Docket Item #14  
BAR CASE# 2005-0165

BAR Meeting  
January 18, 2006

**ISSUE:** Alterations to 1520, 1522 & 1524 King Street

**LOCATION:** 1520, 1522, and 1524 King Street

**Figure 3 - Rear elevation just before 1983 renovation**

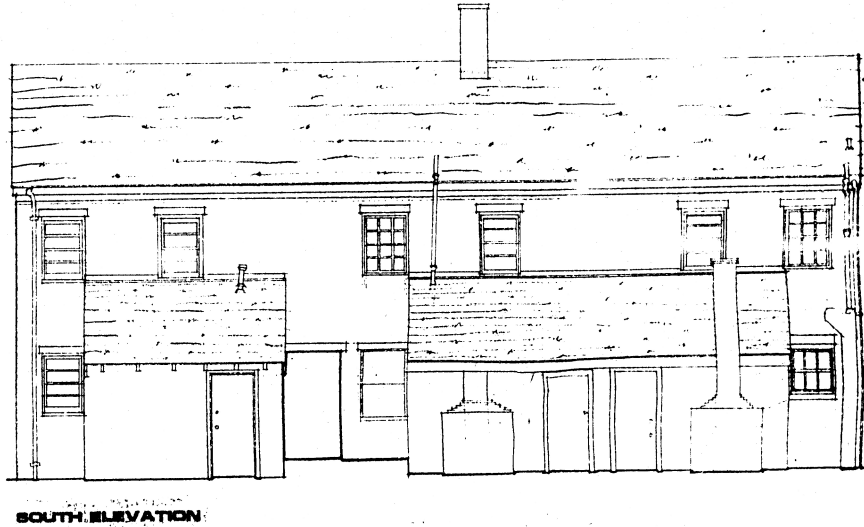
The new continuous rear addition may incorporate portions of the original walls, but does not reflect the architectural character of the original individual rear ells. A drawing of the buildings prior to the 1983 renovation shows that each building had a window in the exposed portion of the rear wall of the main block not covered by the ell.

Staff has no objection to the proposed treatment of the rear elevation. The alterations will result in the reestablishment of three previously existing rear window openings. Staff would prefer that the other three openings be doorways, rather than windows, which would reestablish the presumed original condition. However, the applicant maintains that rear doors are unnecessary to the anticipated use of the buildings. The proposed new windows will match the existing windows in the second story in all respects. The brick used to patch and repair the rear facades of the 100 Year Old buildings should match the original as closely as possible.
